# Staff Report

**Project Name:** Exterior modifications to the east exterior wall and roof

**Case Number:** COA24-0009

**Applicant Request:** Request for a Certificate of Appropriateness to allow for replacement of siding and doors, increase of roof height, and shifting of a portion of the east exterior wall.

*Figure 3: Proposed siding profile on 2659 W. Main St.*

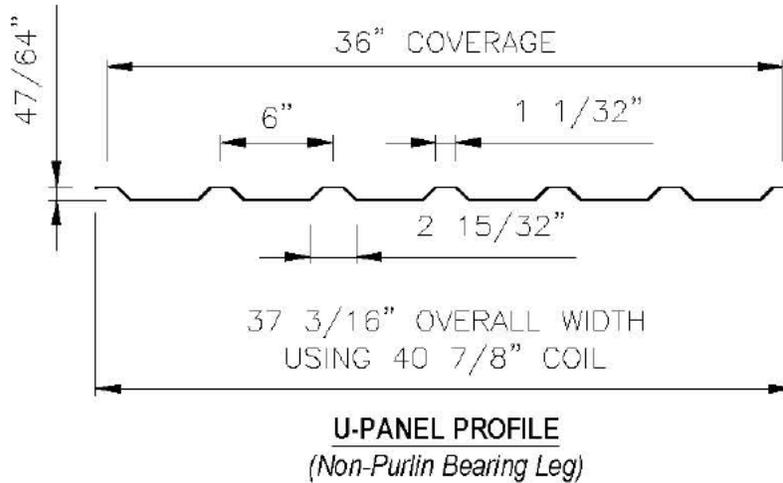
The siding on the east exterior wall was removed due to the collapse. The original siding was metal and meant to imitate vertical wood siding with a grain texture. The applicant noted this type of siding is no longer manufactured. The proposed siding will match what is on building two and the parapet wall along the front façade of the original building. The proposed siding is a U-Panel design and will be similar in color to what was previously on the building but will be a different profile.

The removal of material occurred due to the roof collapse and life safety concerns. This application does not call for the further removal of any features. The proposed siding does not match what was previously on the building, as it is no longer manufactured, but it will match in color to the existing and in profile to other non-historic, siding on the building. This standard appears to be met.

Figure 4: Views of mechanical existing and proposed mechanical equipment from W Main St, 2659 W. Main St.

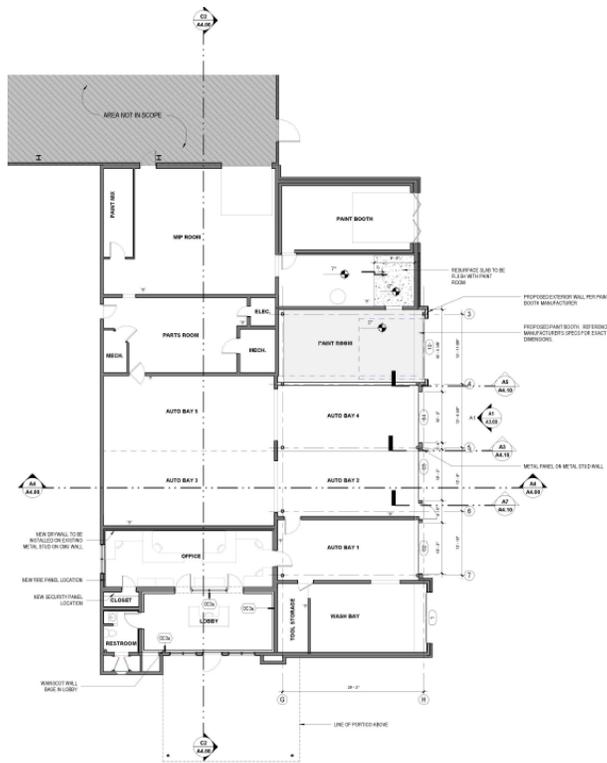
Much of the roof top equipment will be replaced, with the addition of a new exhaust fan, as required by current building code, and the new paint booth equipment. The proposal does not include screening, as the equipment was previously not screened from view. Additionally, staff recommended not screening the equipment utilizing a parapet wall running across the width of the building. The increase in height from the parapet and the location closer to the front of the building would create incompatible massing on the roof.

- 3.54 Minimize the visual impacts of skylights and other rooftop devices.
- (iii) *The proposal includes the reinstallation of previously existing equipment and the installation of a new exhaust fan, required by building code, and a unit on the paint booth, required by EPA regulations. Staff recommended not screening the equipment, as the screening would have negatively impacted the historic integrity of the building by being incompatible in scale, massing, and form. The equipment could be painted to reduce some of the visual impact it may have on West Main Street.*

1. The existing elevations need to accurately depict the removed garage doors, and visually show that the proposed doors are in-kind replacements on the proposed elevations and material specifications sheet.
2. Paint the mechanical equipment a color that will further reduce their appearance.

Figure 7: Proposed east elevation, 2659 W. Main St.

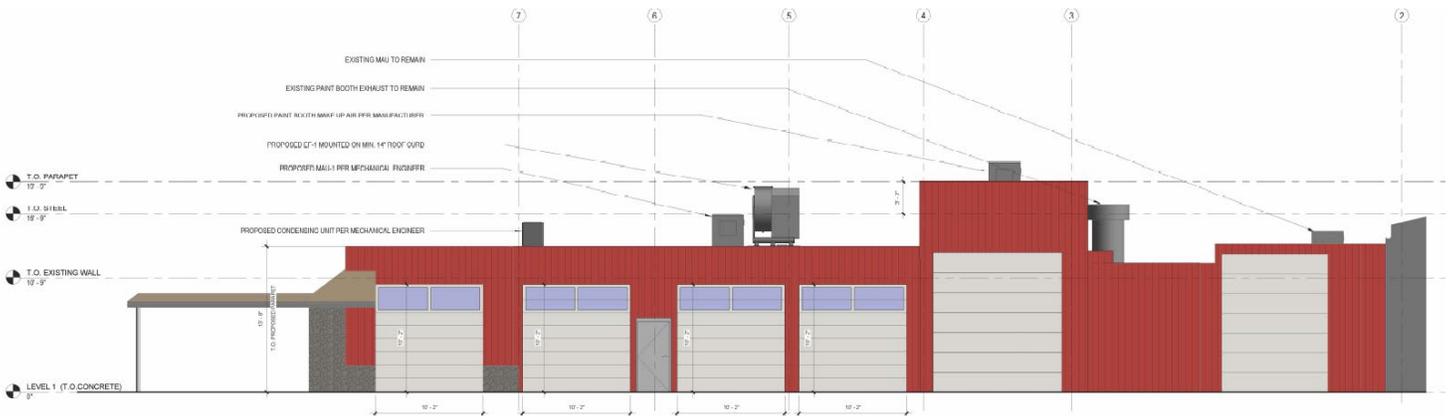
The roof collapse and resulting demolition removed the exterior siding and garage doors previously on the building. The siding could not be replaced in-kind as it is no longer manufactured. The applicant is proposing to replace it with siding that matches the profile of added and previously replaced siding and will be the same color as the original building. The garage doors were noted as being replaced in kind, but the drawings are not consistent in their depiction of the windows in the garage doors. As shown on the elevations and specification sheet, this standard does not appear to be met.

Staff finds that the proposed work is predominantly compatible with the historic building. The proposed siding will be the same color as the existing siding and will be the same profile as other replacement siding on the original building and what was utilized on a previous addition. The plans do not consistently show the use of in-kind garage doors, but their use is included in notes on the plans and material specification sheets. The proposed booth and mechanical equipment are required by the EPA and current building codes. The required increase in size for the paint booth will only affect that portion of the building and is setback greatly from the front of the building. The reinstalled and new roof top equipment are not screened, as the screening would negatively impact the historic integrity of the building. As the plan set currently exists, the proposed garage doors do not meet this criterion. This criterion has not been met, but can be met by staff's recommended condition as referenced below.
